**ISSUE:** Certificate of Appropriateness for alterations

**APPLICANT:** Old Presbyterian Meeting House

**LOCATION:** Old and Historic Alexandria District  
419 South Royal Street

**BAR#2024-00040**  
**419 S Royal Street**

419 S Royal Street- BAR Application for revised light pole location.

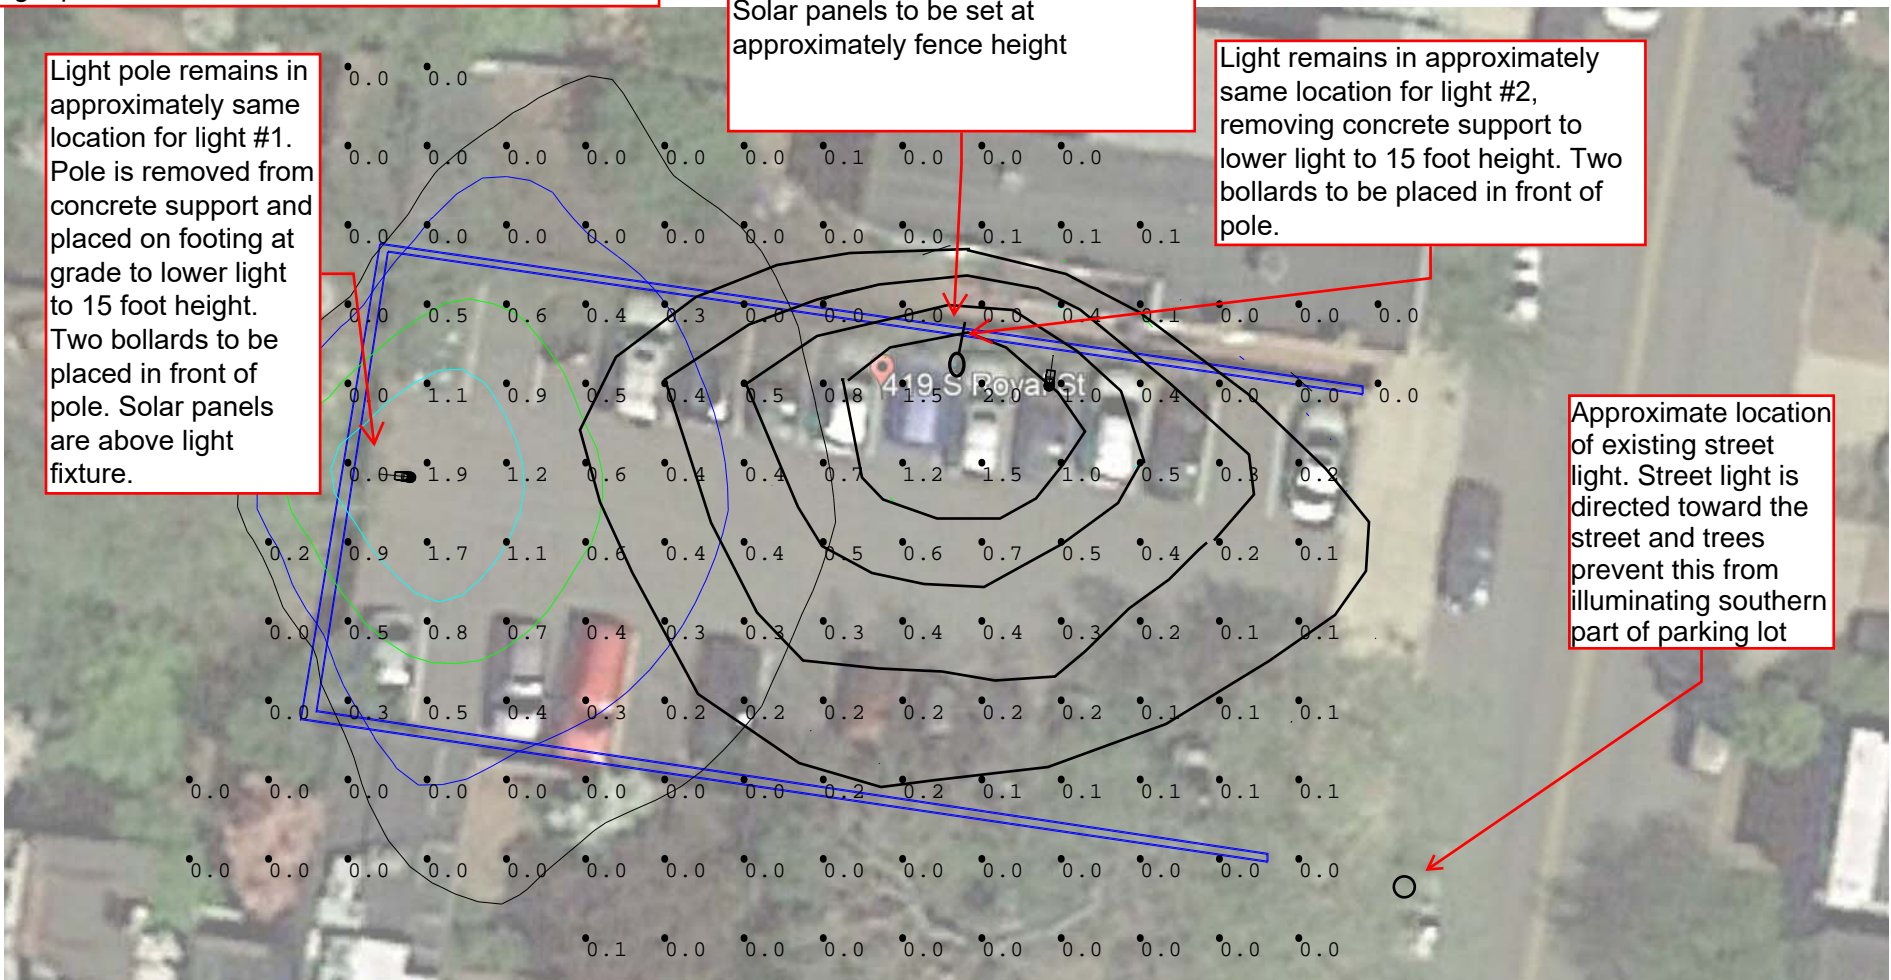
Text (numbers) indicate approximate light levels for proposed light pole locations.

Light pole remains in approximately same location for light #1. Pole is removed from concrete support and placed on footing at grade to lower light to 15 foot height. Two bollards to be placed in front of pole. Solar panels are above light fixture.

Solar panels to be set at approximately fence height

Light remains in approximately same location for light #2, removing concrete support to lower light to 15 foot height. Two bollards to be placed in front of pole.

Approximate location of existing street light. Street light is directed toward the street and trees prevent this from illuminating southern part of parking lot

Letter 2 - Combined from two separate emails and photograph - Docket Item #4

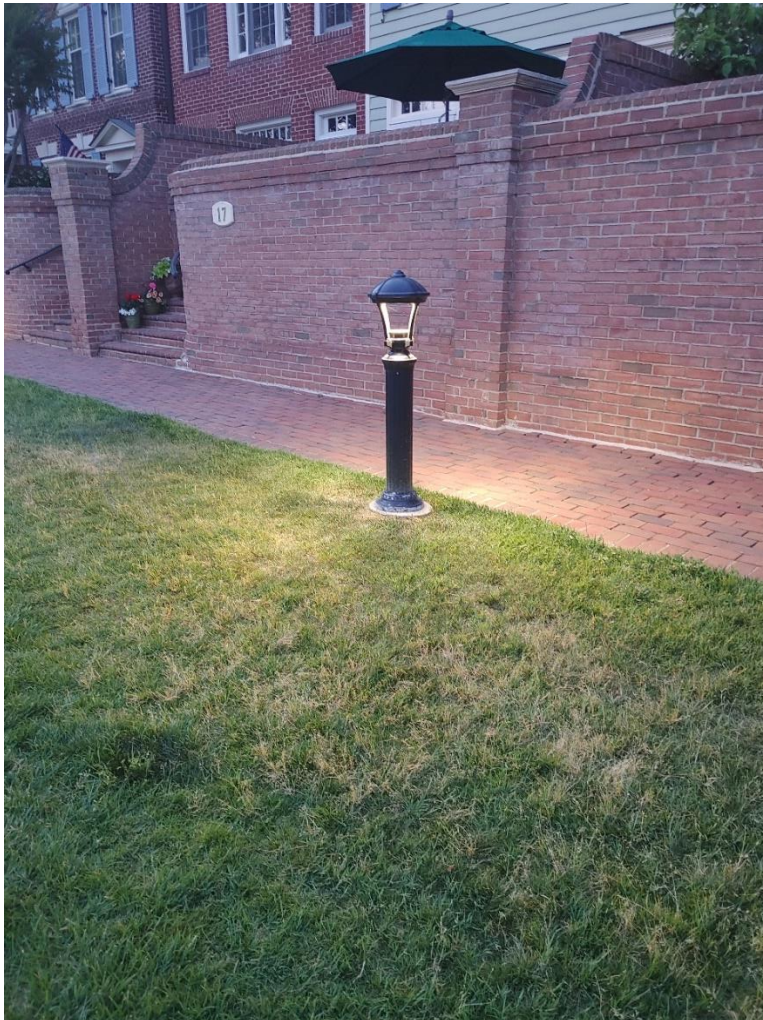
please send this picture to the board. this light is on the walk that is at Union street and wilkes, that goes to the water front for the housing community there, think that community called harbor terrace. these can be taller to the fence line, but they are solar, and more attractive and historical looking and the example I used at the last hearing that was ignored. But I would like to know

why this property was required to have more attractive lighting, and the church property was not. to me if these lights that could be taller but stayed below the fence line, would produce adequate lighting for such a small parking area, and not impact neighbors historic houses so close to the church lot.
